PLANNING & ZONING CASE NO. SP2026-015

SP2025-042; Site Plan for 2200 Ridge Road
Please address the following comments (*M= Mandatory Comments; I = Informational Comments*)

SITE PLAN

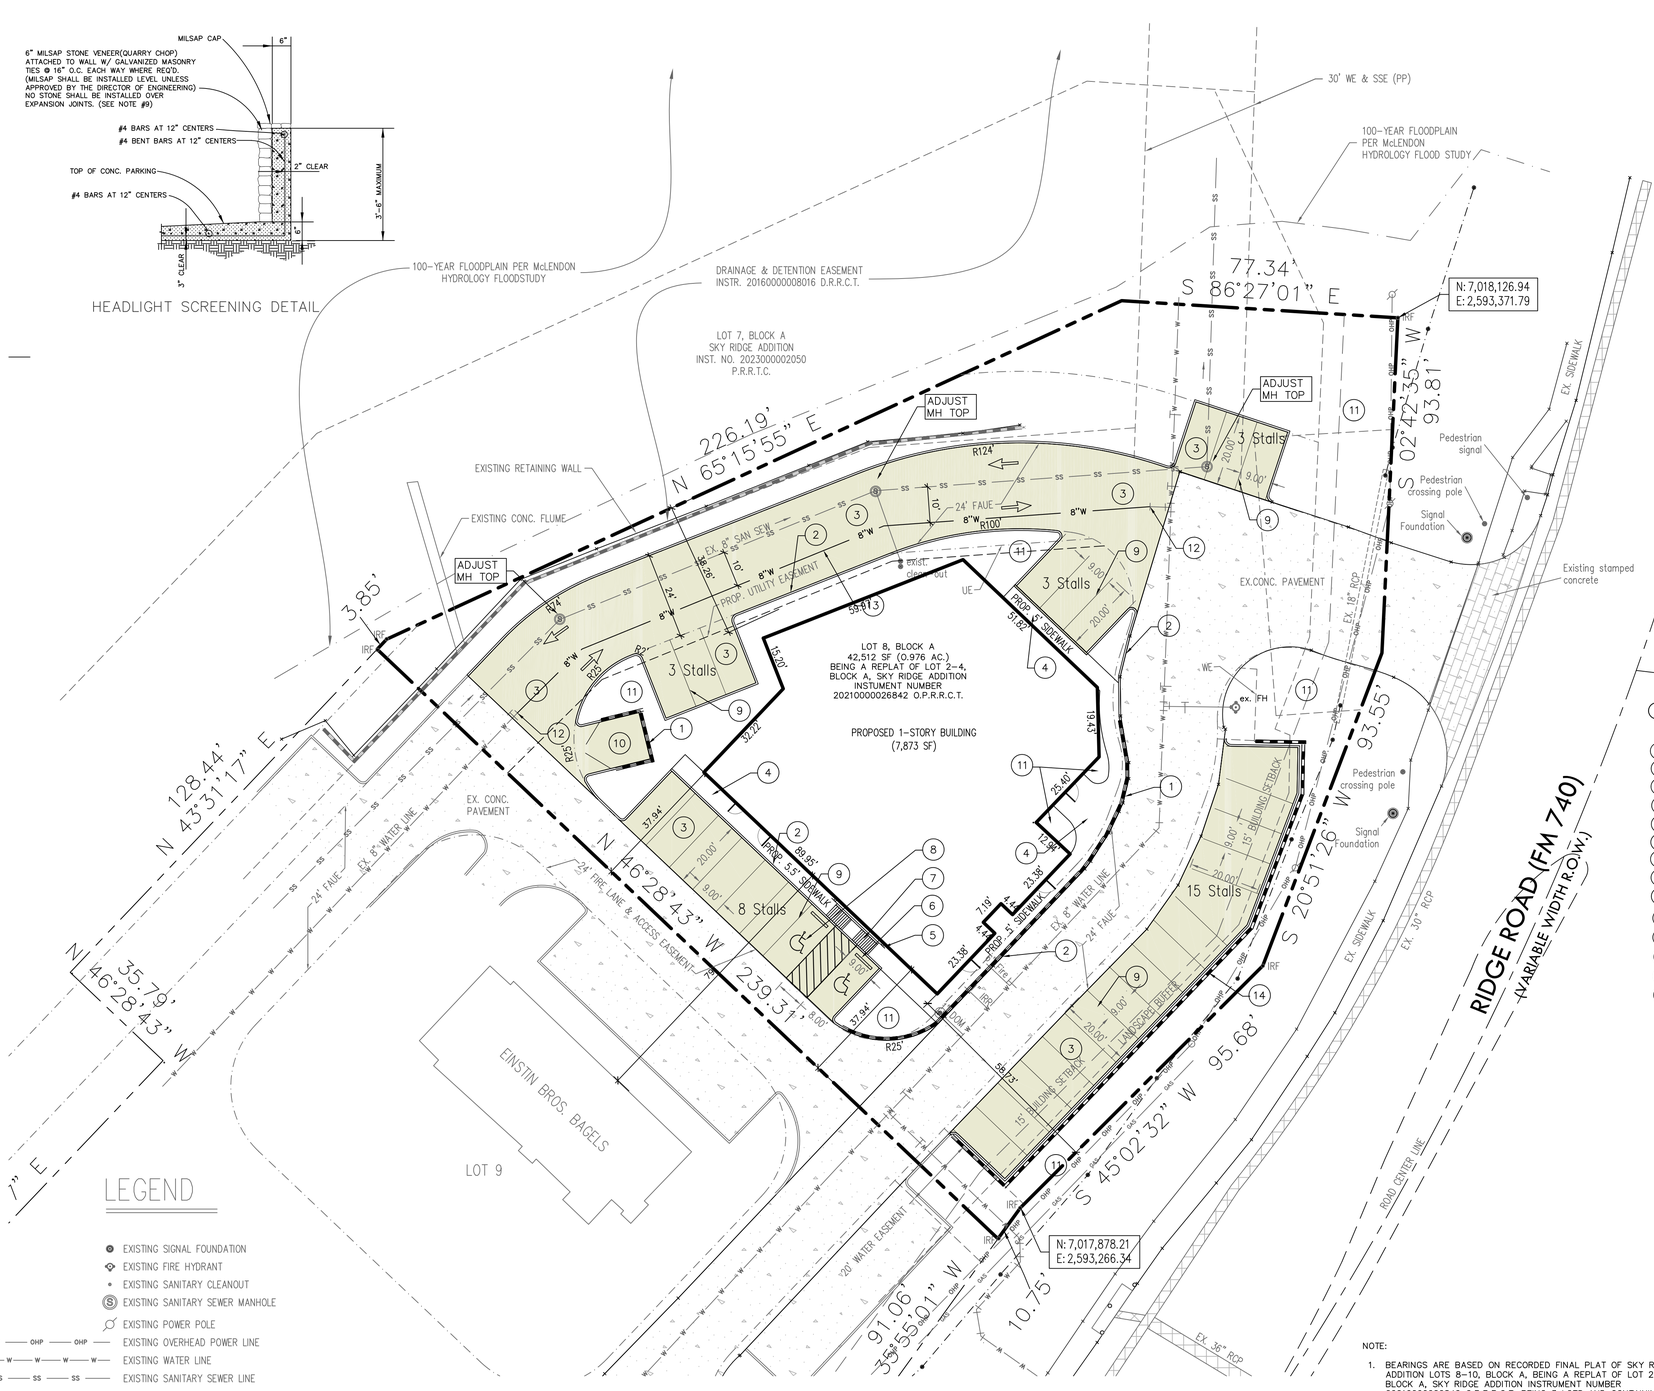
M.2 Site Plan.
(1) Please update the parking table, as 32 parking spaces are required and 32 parking spaces have been provided. (*Subsection 03.04. B, of Article 11, UDC*)

(3) All head in parking adjacent to a roadway is required to provide headlight screening. Variance requested.

Henry Nguyen Consulting's response: Parking table has been updated showing 32 parking spaces.

Henry Nguyen Consulting's response: A 3' wall was added to provide headlight screening.

BUILDING ELEVATIONS
A203

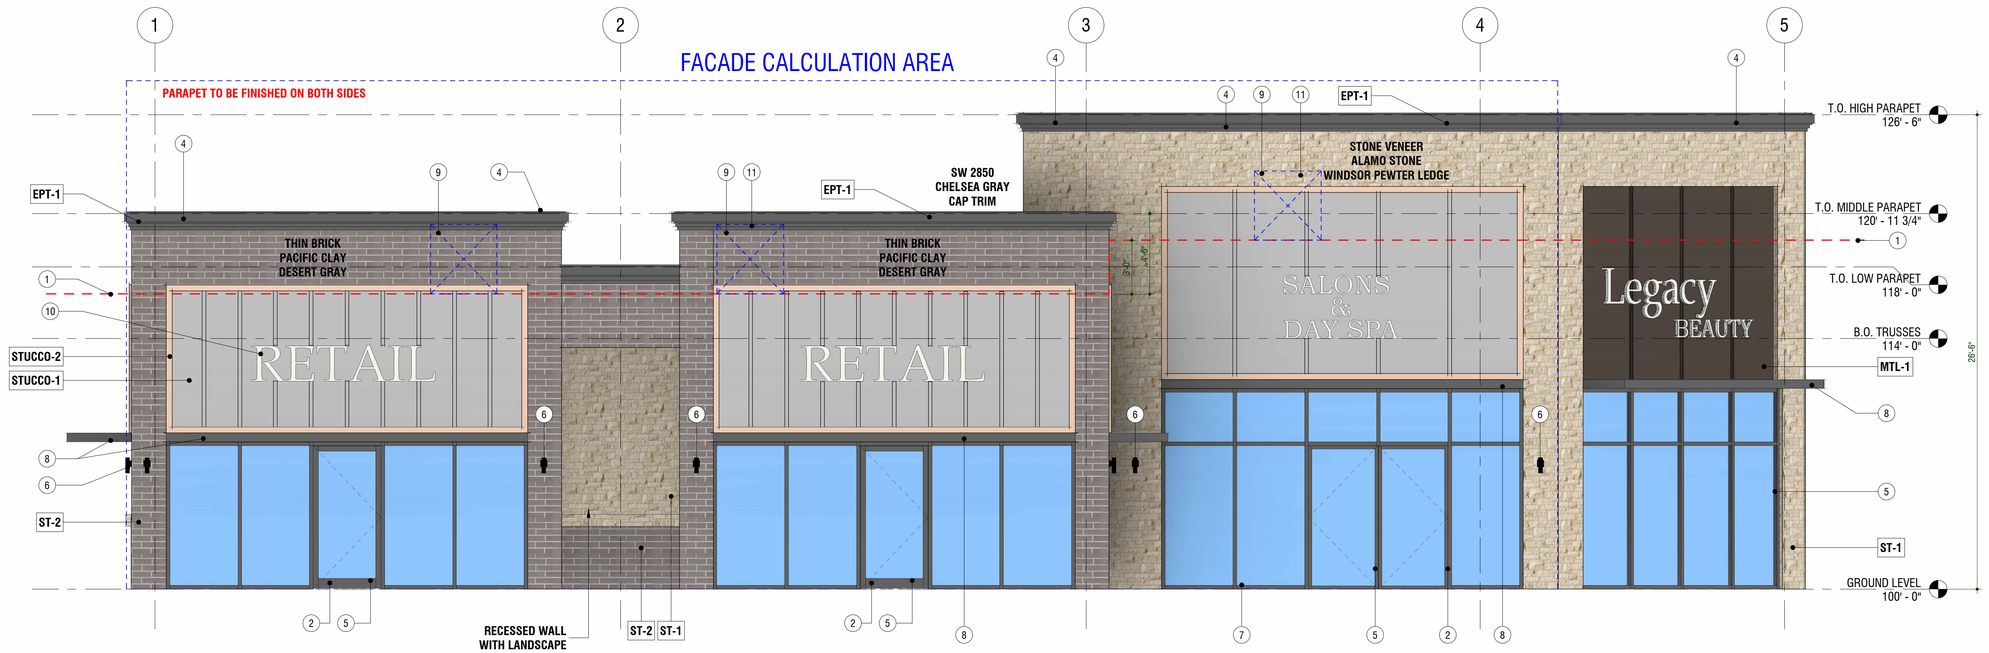
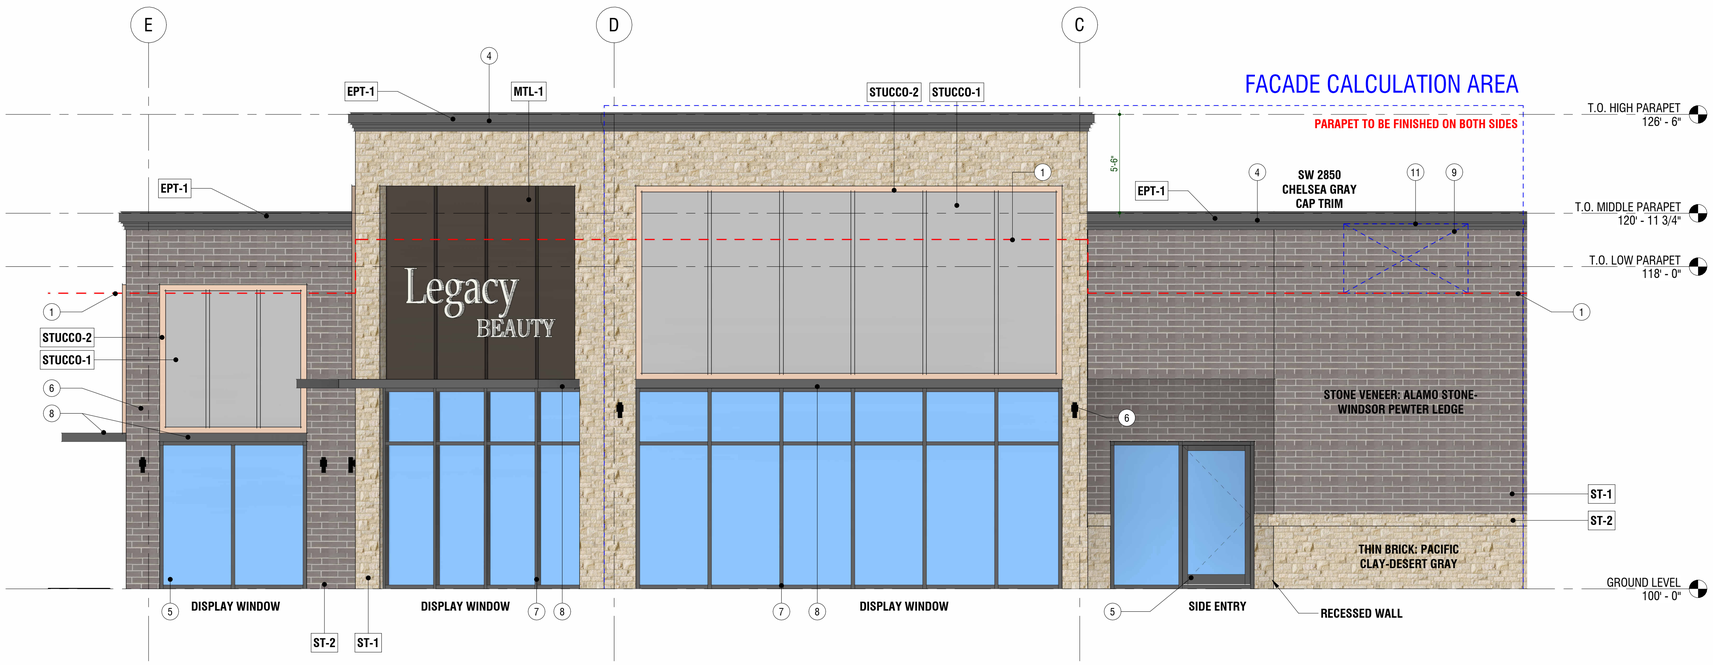
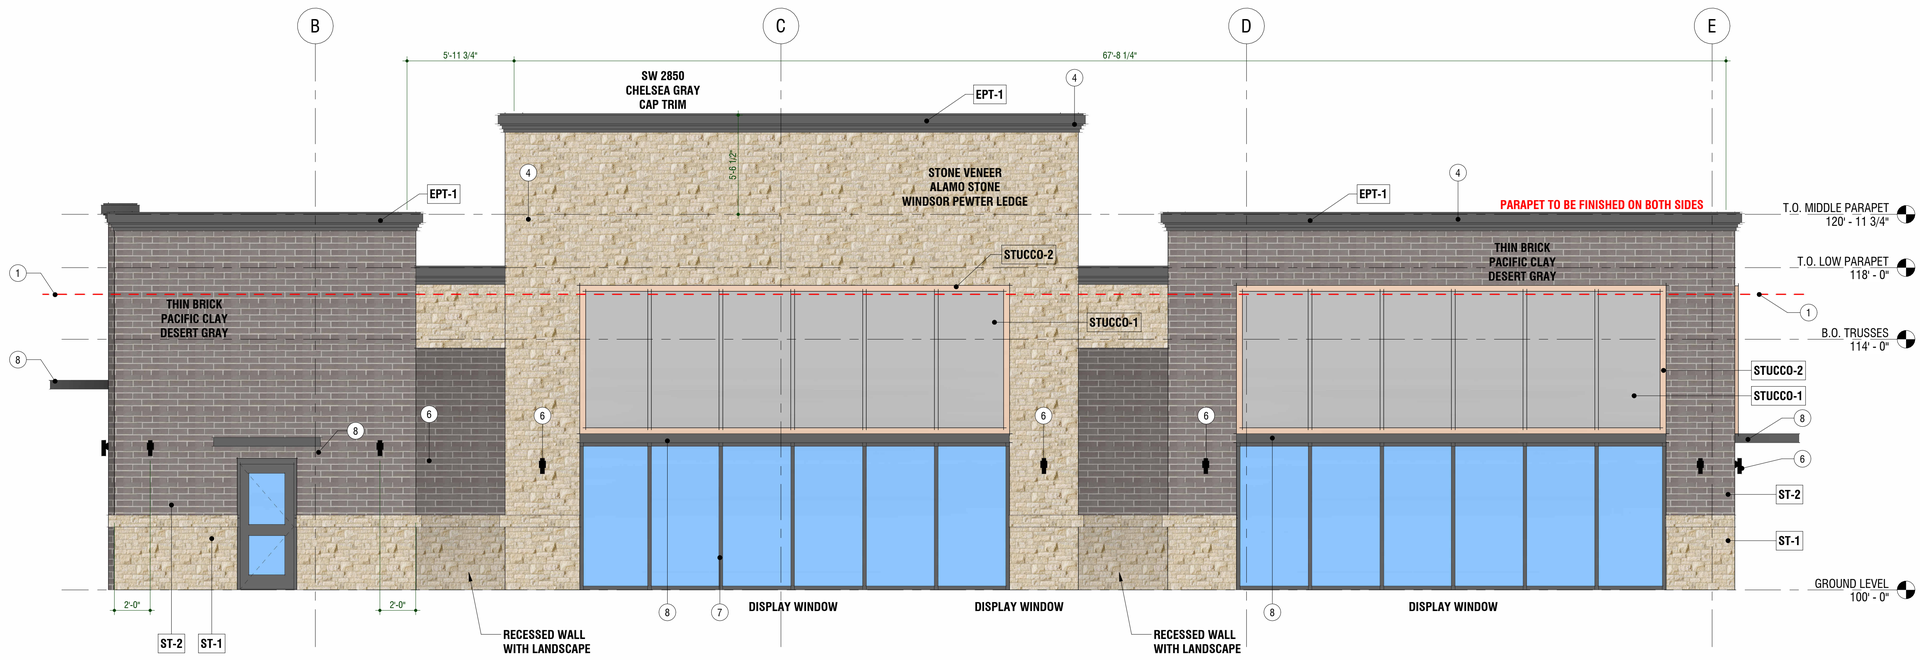
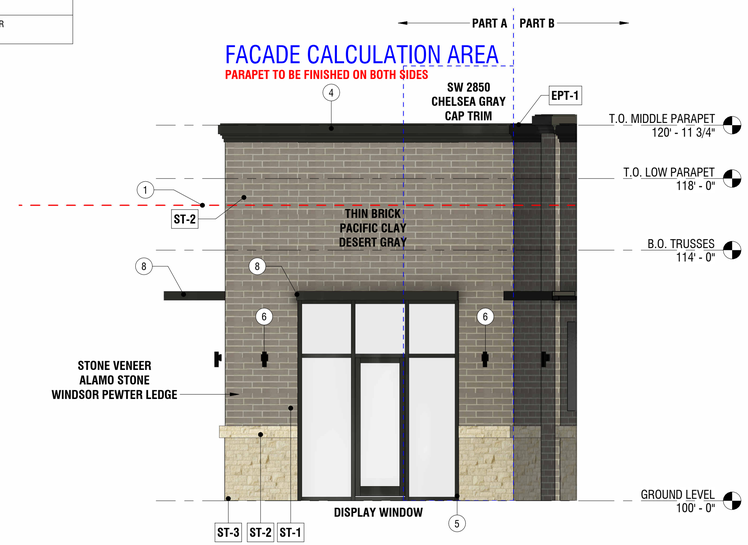
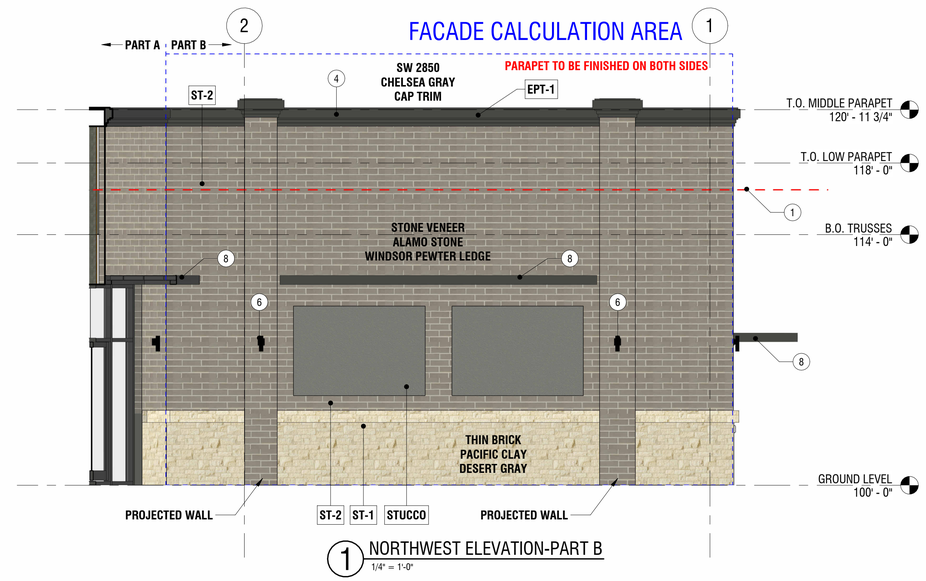
(1) Please crosshatch the RTUs on the elevations. The RTUs must be fully screened by the parapet. Please pay attention to this due the building being lower than the road. (*Subsection 01.05.C, of Article 05, UDC*) Staff believes that the RTUs will be visible from ridge road because of the elevation change. Based on this staff has added a condition of approval that will require louvers if they are visible.

(4) The subject property is located within the Scenic Overlay District and is required to provide primary articulation on each façade. In this case, the proposed building elevations do not meet any of the primary articulation standards. (*Subsection 04.01, of Article 05, UDC*) Variance requested.

B+A Architecture's response: Aknowledged. We added a note that the RTUs will be screening if it is visible from the Ridge Road.

B+A Architecture's response:

The proposed building has been designed with an irregular configuration, resulting in six distinct façade sides. This geometry is a direct response to the unique constraints and conditions of the site and its surrounding context.

We acknowledge the review comments M.10.7 and M.10.9 regarding the requirement to provide primary articulation on all building elevations. Due to the building's irregular form, achieving full compliance with all primary façade articulation standards on every elevation presents significant design challenges.

In this resubmittal, we have revised the building elevations to ensure that the primary façades comply with the majority of the Primary Building Façade standards. The remaining façades have been designed to maintain consistency in materials, detailing, and architectural features in accordance with Subsection 06.01-C.(5), which requires four-sided architectural treatment.

While these secondary façades may not incorporate all seven primary façade articulation elements, they are designed to provide a cohesive and high-quality architectural expression consistent with the intent of the ordinance.

SITE LIGHTING PHOTOMETRICS

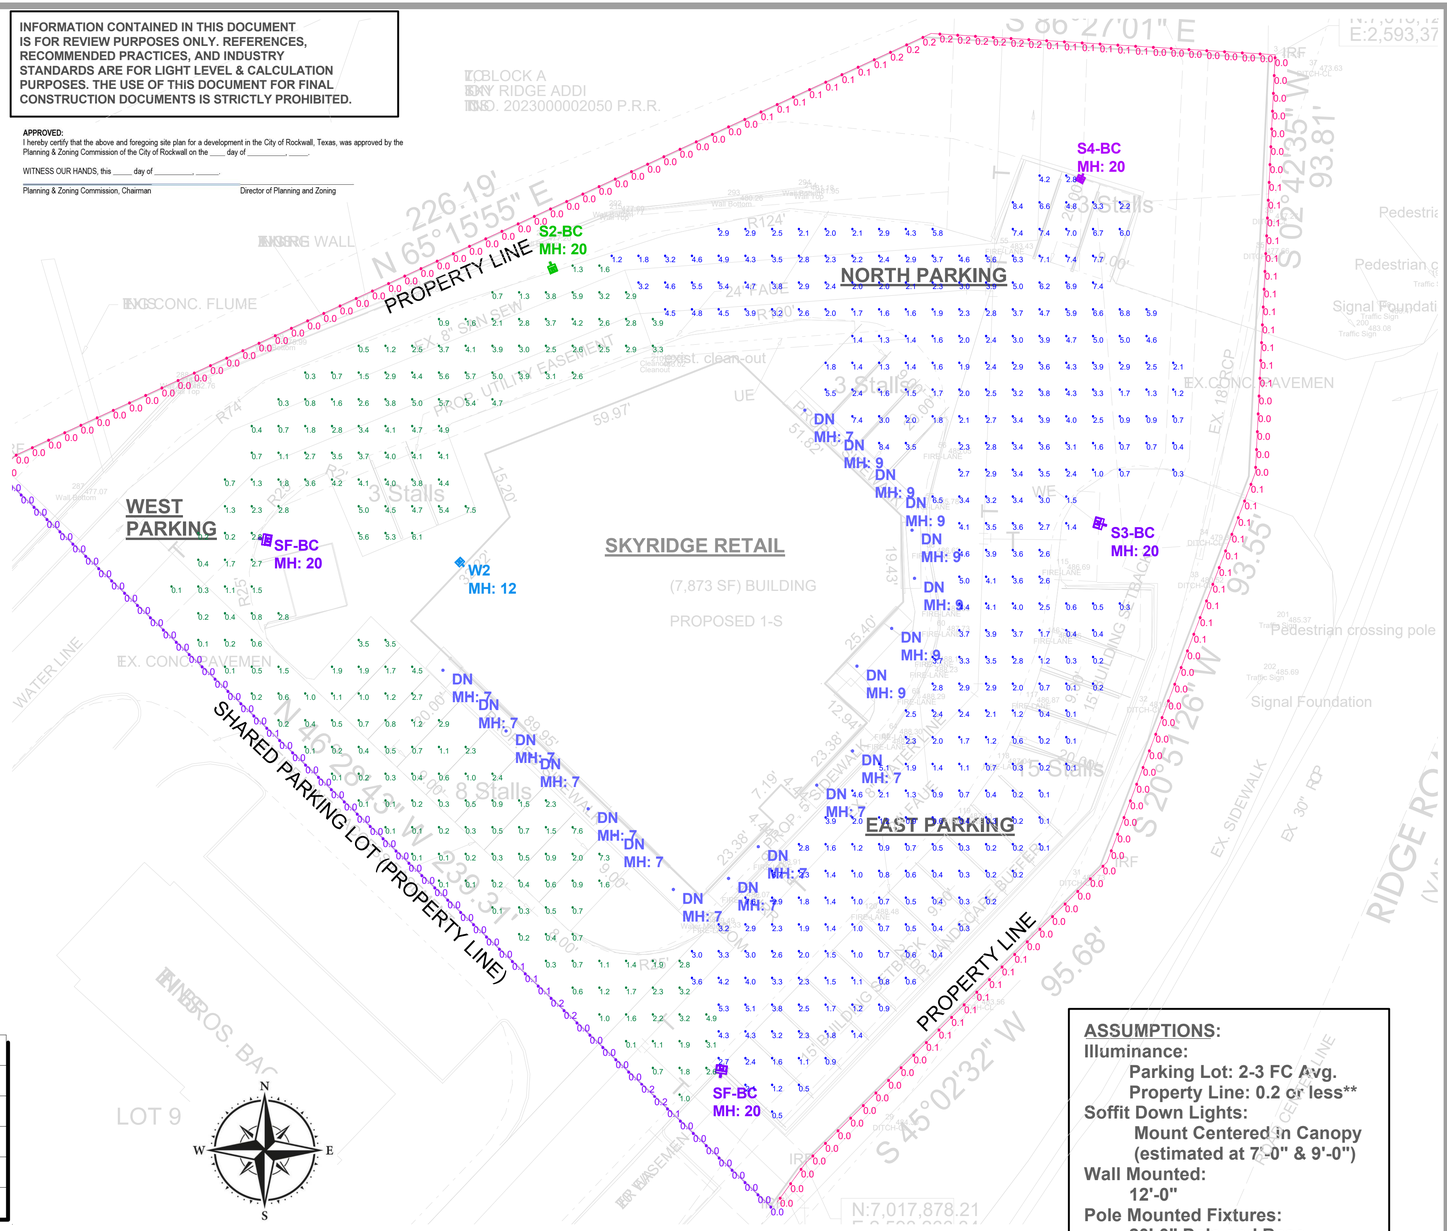
M.4 Photometric Plan

(1) Provide the same site data information required in Section 2.1 Site Plan: Miscellaneous and Density and Dimensional Requirements of this checklist. (*See Sec. 2.1 of the checklist*)

(2) Light levels shall not be greater than 0.2 FC at all property lines. Please correct the photometric plan to address this requirement. (*Subsection 03.03, of Article 07, UDC*) Variance requested.

B+A Architecture's response: Same site data information required in Section 2.1 has been provided on the photometric plan.

B+A Architecture's response: We have revised the photometric plan to show that light levels are less than 0.2 FC at all property lines. Please see attached revised site photometric plan.
